Access Compliance Report

Public Rights-of-Way

(Curb Ramps)

Intersection ID: 14938	Main Street: COLVILLE_RD	Cross Street: N_LAUREL_AV	Location: NW
ADA ID: 9D50B8FD852E	Ramp Type: Perp	Initial Pass/Fail: Fail	Overall Compliance: No
Severity Score: 25			
Codes/Mitigation Info/Possible Solution		Field Measurements/Component Compliance

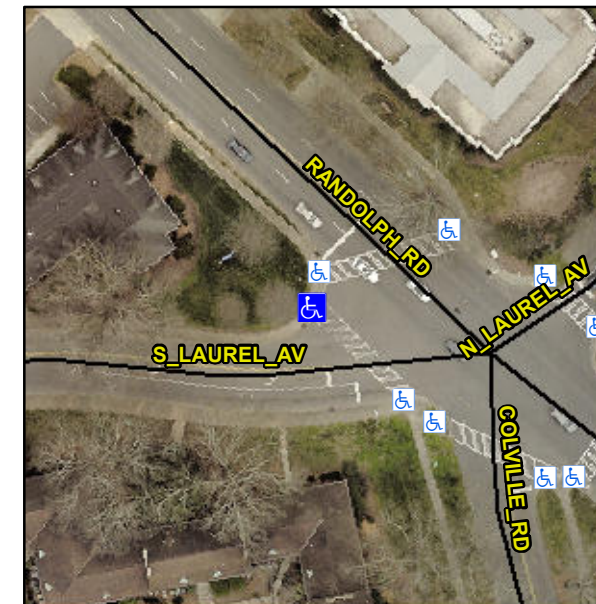
Not Found, R304.5.3

Compliance	Description	Data	Compliance	Description	Data
N/A	Ramp Length (in)	61.0	Yes	Ramp Slope (%)	6.9
Yes	Ramp Width (in)	48.0	No	Ramp XSlope (%)	11.1
N/A	Flare Type LT	N/A	N/A	Flare Type RT	N/A
N/A	Flare Slope LT (%)	N/A	N/A	Flare Slope RT (%)	N/A
N/A	Flare Traversable LT?	N/A	N/A	Flare Traversable RT?	N/A
N/A	Landing Length (in)	N/A	N/A	DWS Provided?	N/A
N/A	Landing Width (in)	N/A	N/A	DWS Contrast?	N/A
N/A	Landing Slope (%)	N/A	N/A	DWS Length (in)	N/A
N/A	Landing X Slope (%)	N/A	N/A	DWS Full Width?	N/A
N/A	Landing Curb? (Y/N)	N/A	N/A	DWS Offset (in)	N/A
N/A	Shared Landing?	N/A			
N/A	Gutter Ponding?	N/A	N/A	Gutter Slope (%)	N/A
N/A	Gutter Lip Ht (in)	N/A	N/A	Gutter X Slope (%)	N/A
N/A	Painted X Walk1?	Yes	N/A	Painted X Walk2?	N/A
	X Walk 1 Direction	To SE		X Walk 2 Direction	N/A
N/A	X Walk 1 Width (in)	122.0	N/A	X Walk 2 Width (in)	N/A
	X Walk 1 Slope (%)	0.1		X Walk 2 Slope (%)	N/A
	X Walk 1 X Slope (%)	9.2		X Walk 2 X Slope (%)	N/A

Remove & Replace Entire Ramp.
